PORT LANSING SITE READINESS PROJECT
QuestCDN Project #10267490
ADDENDUM #2

Date: July 15, 2026
Project: Port Lansing Site Readiness Project
Owner: Capital Region Airport Authority
Engineer: Kimley-Horn of Michigan
Subject: Response to Bid Clarification Questions

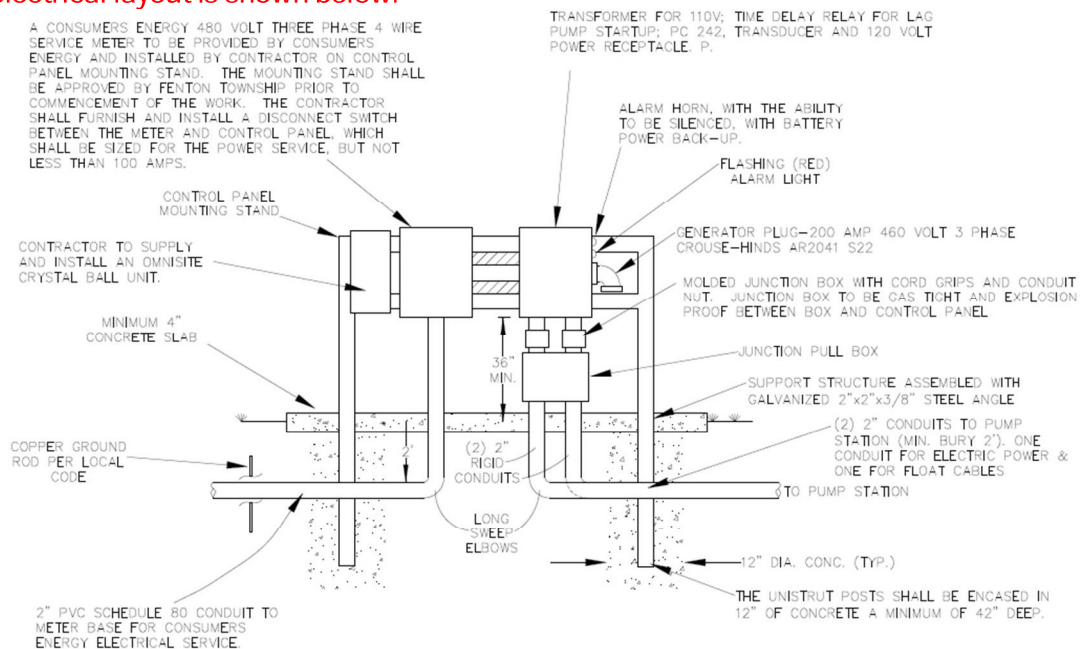
14. Is there any way we can ask the engineers if they have a section view of the lift station or even the electrical layout they want for the racks and equipment?

See drawings in this attached Addendum 2 for section of lift station. An example of electrical layout is shown below.
